# 1307 WALLER ST

**From:** "Mitchell, Amber" <Amber.Mitchell@austintexas.gov>  
**Date:** July 28, 2013 12:53:09 PM CDT  
**To:** T English <[REDACTED]>  
**Cc:** "Hadley, Bill" <Bill.Hadley@austintexas.gov>, "Gomez, Ernesto" <Ernesto.Gomez@austintexas.gov>, "Jones, Michael J. [PDRD]" <Michael.Jones2@austintexas.gov>, "Halm, Andy" <Andy.Halm@austintexas.gov>  
**Subject:** RE: 1307 Waller St. Alley Continuation

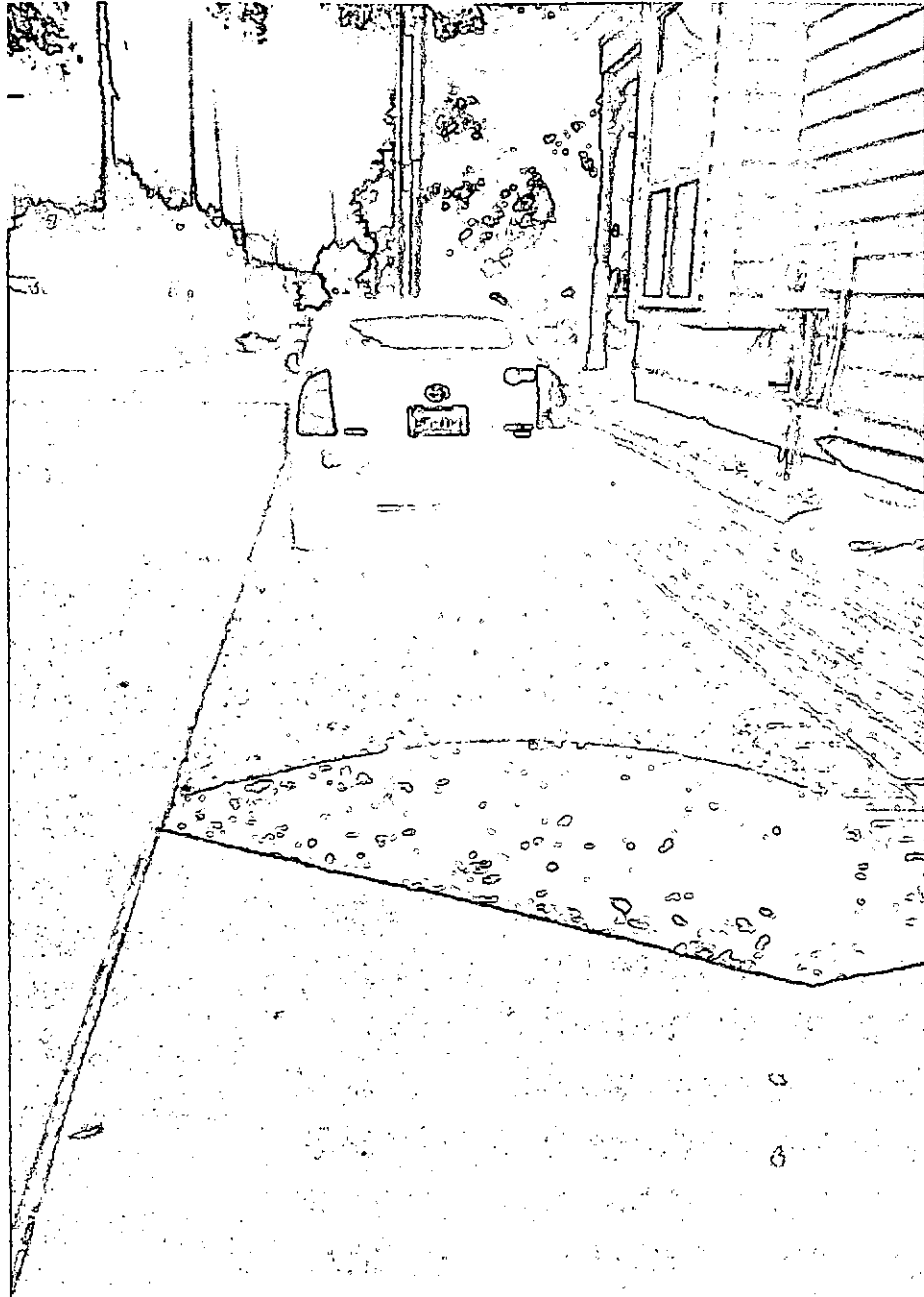
Hi Toria – My apologies for the delay in my response; it's been quite busy around here. Staff met to review your proposals: Regarding the request to install street grade concrete within the alley along approximately half of your property the consensus is that the expansion of the alley in this one location wouldn't be for public benefit and could potentially create a precedent for approvals of this nature. As such staff is denying the request to make this improvement.

Regarding the retaining wall within the right of way, Dr. Hadley had the following comments:

It appears that the retaining wall is planned to support the existing driveway to the residential garage.

For this location the owner should submit for review the drawings of the proposed retaining wall including dimensions, thicknesses, etc.

The details should also indicate how the proposed retaining wall will be connected to the existing driveway and how pavers will be installed on the retaining wall as well.
